## **Kaufland Australia Pty Ltd**

Construction of two-storey retail development for Kaufland Supermarket including internal supporting small tenancies, solar-panels, associated undercroft car park, offices, various signage, and landscaping.

### **10 Anzac Highway Forestville**

090/E004/18

Figure 1: Concept Plan Map Un/11 – from Unley Development Plan

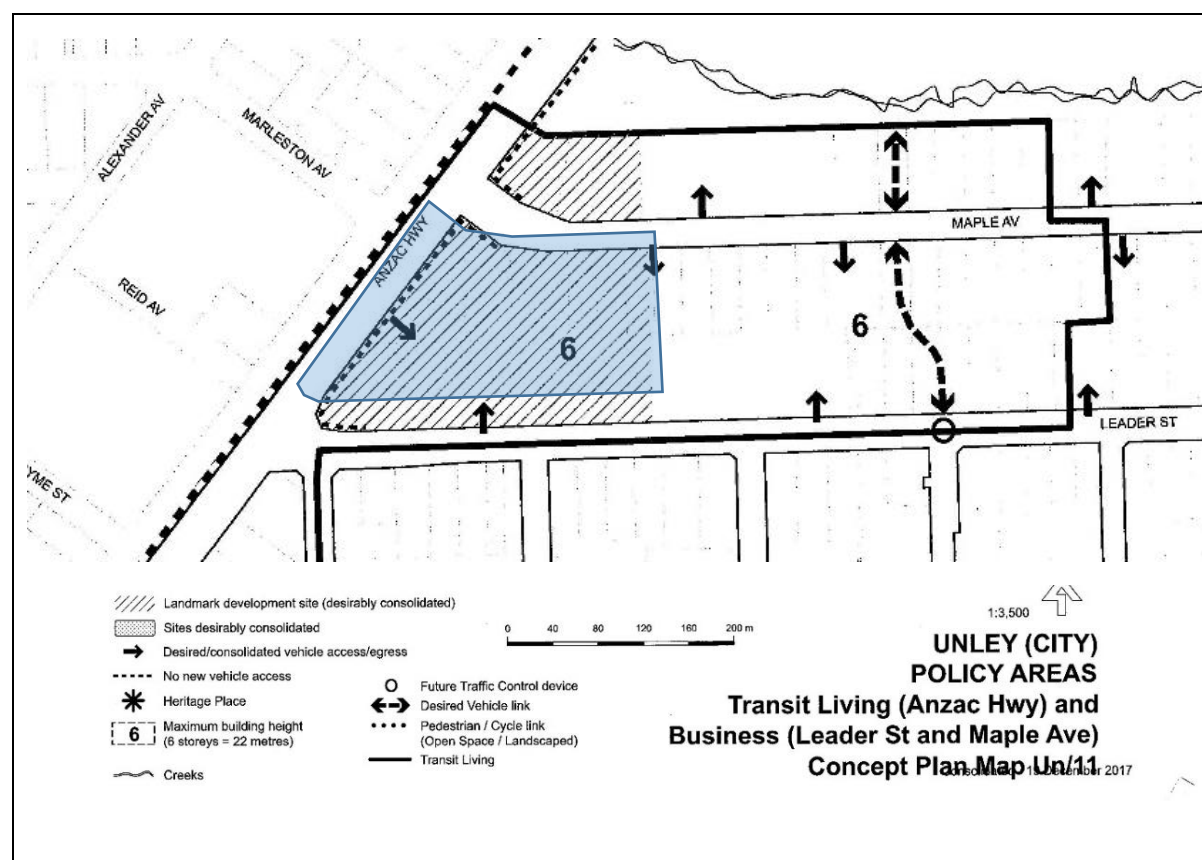
D3	P158	Restricted and consolidated vehicle access points will be available, and access will be mainly from secondary road frontages, limited rear access lanes and through-site integrated and shared rights-of-way.	With reference Figure 1, vehicle access is approximately where shown as desired. <b>Except</b> for the laneway and access points along the eastern most boundary.
D4	P158	Controlled pedestrian and cycle crossing points will be focused and consolidated at key locations.	Not shown on drawings.
